STANDARD DEPARTURE CHART - INSTRUMENT

RJNH / HAMAMATSU

Civil Aviation Bureau, Japan (EFF:21 APR 2022)

TACAN Y RWY27

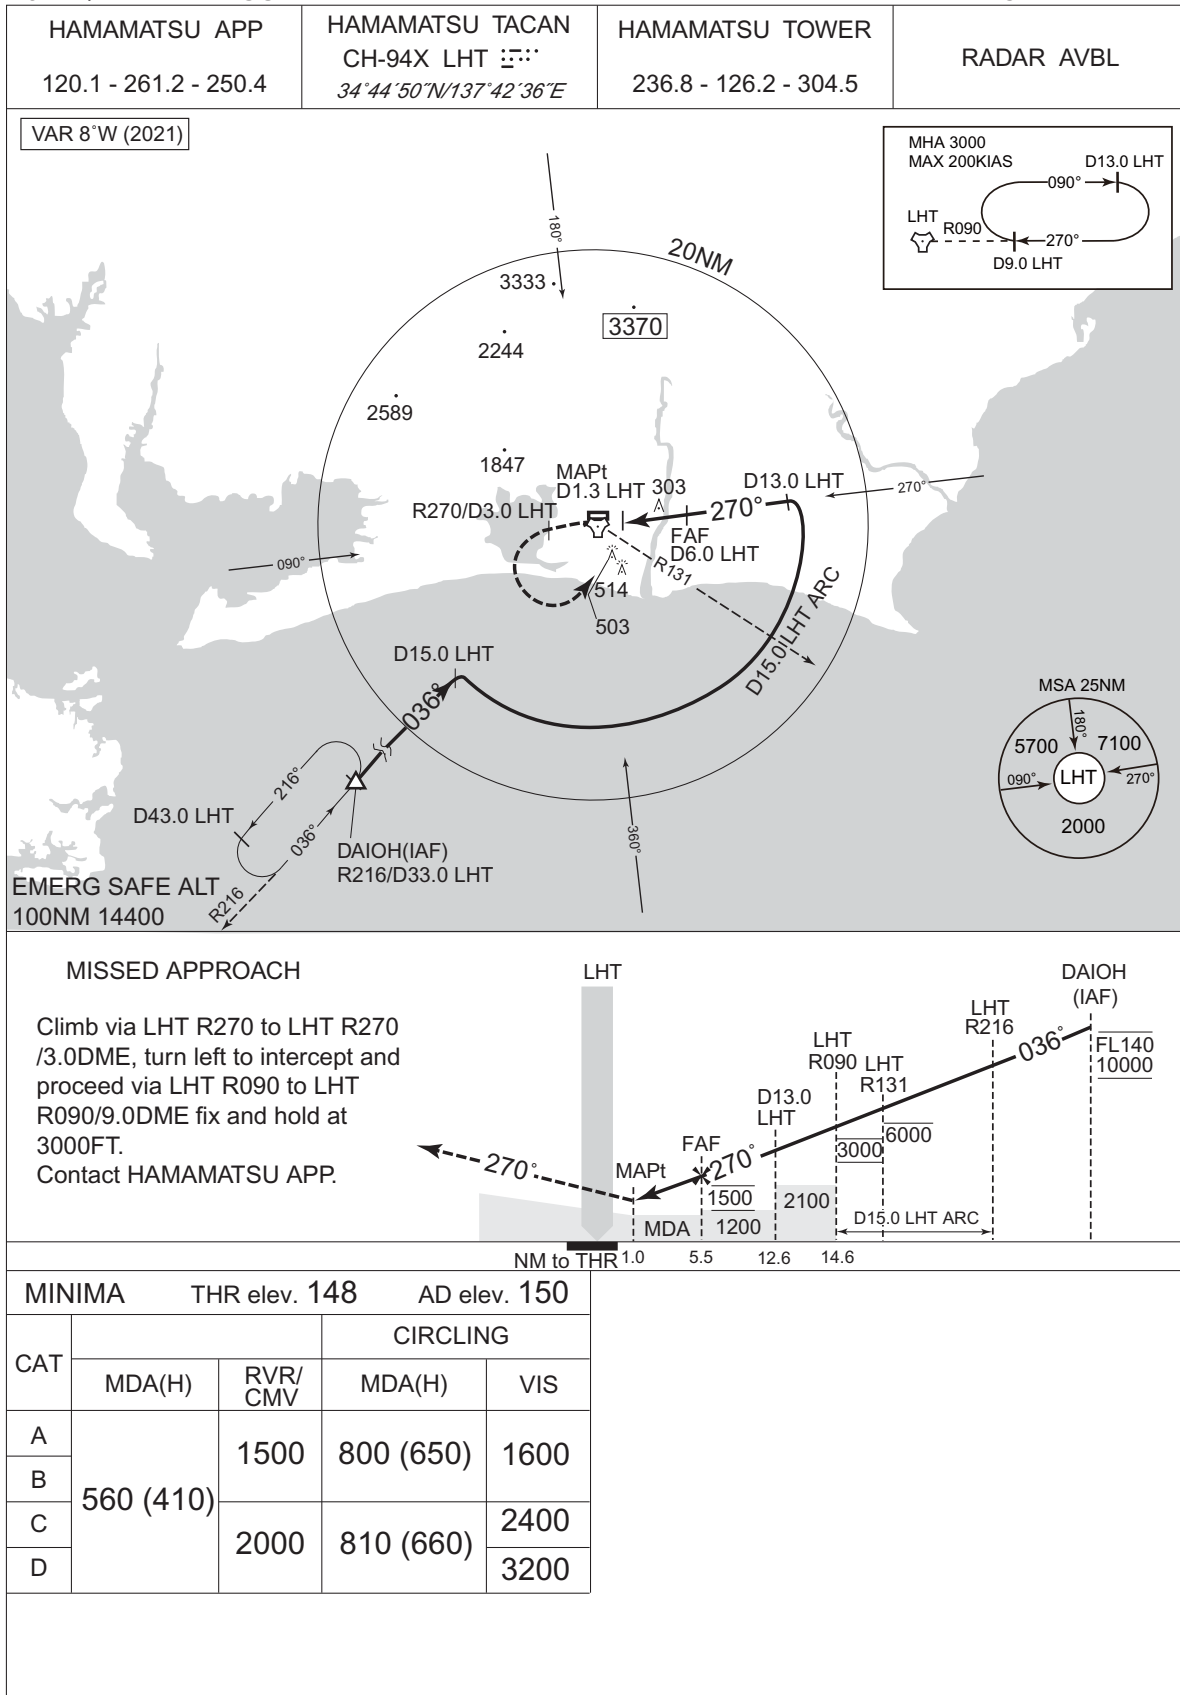
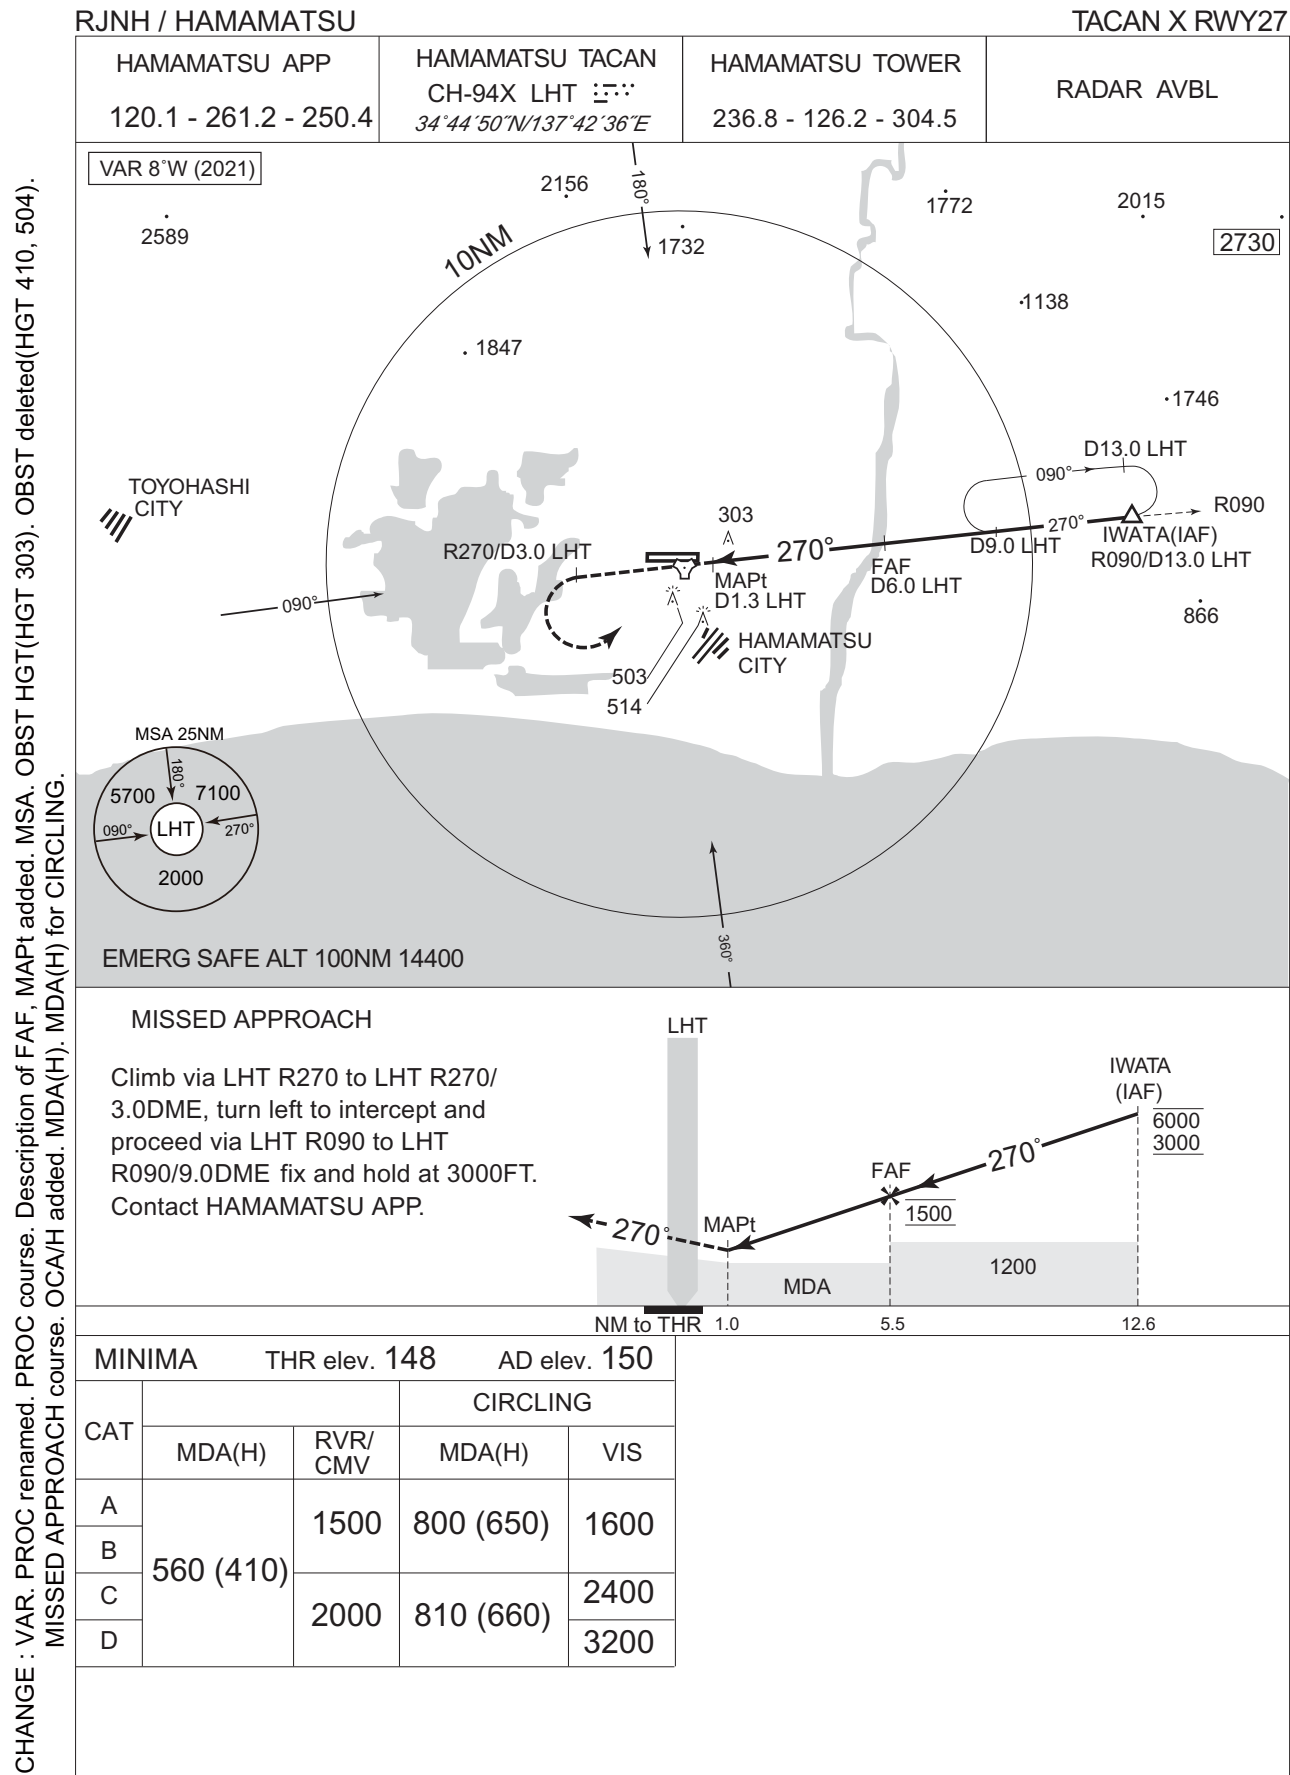
CHANGE : VAR. PROC renamed. PROC course. Description of FAF, MAPt added. MSA. HLDG pattern added. OBST added(HGT 303). OBST deleted(HGT 410, 504). MISSED APPROACH course. ALT restriction(DAIOH, LHT R090). OCA/H added. MDA(H). MDA(H) for CIRCLING.
